MEMORANDUM

To: Development Review Board
From: Mary O'Neil, AICP, Principal Planner
Date: July 17, 2018
RE: ZP18-0894LL / AP 14 Peru Street and
ZP18-0895LL / AP 16 Peru Street

Request: Appeal of an administrative denial of a boundary line adjustment between 14 and 16 Peru Street.

Google Street view, taken October 2014. Note appearance of 16 Peru prior to alterations, and narrow width of 14 Peru Street driveway.

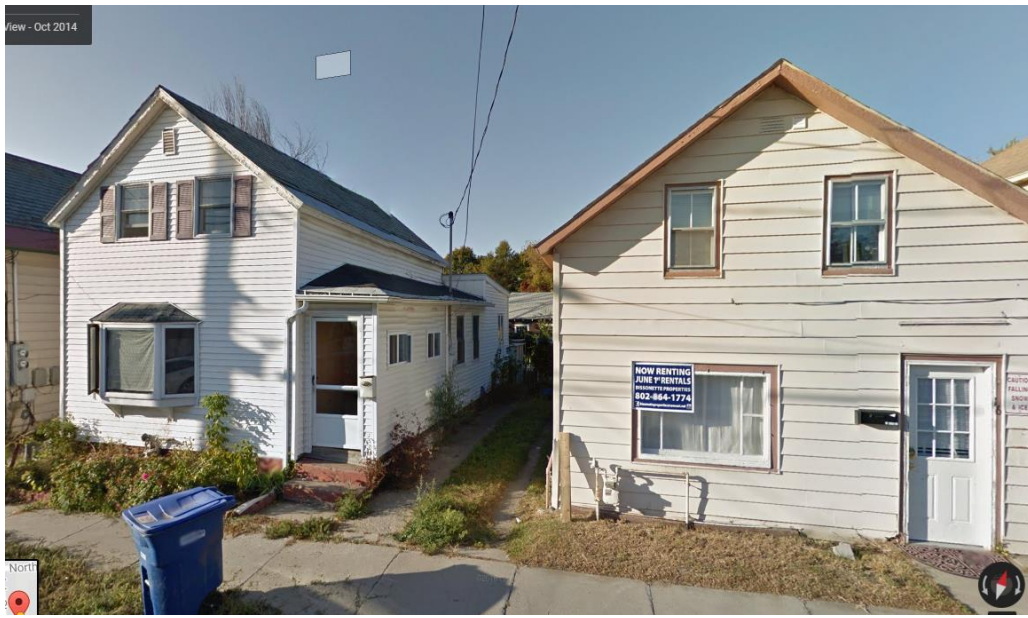
90° angle parking requires a width of 9'. By the existing site plan, there is currently only 5' of width in which to park vehicles at 14 Peru Street; with the boundary line adjustment, that width is reduced to 3 ½ - 4 feet on that parcel; insufficient to meet the minimum parking standard and further increasing the level of non-conformity to parking. **Adverse finding.**
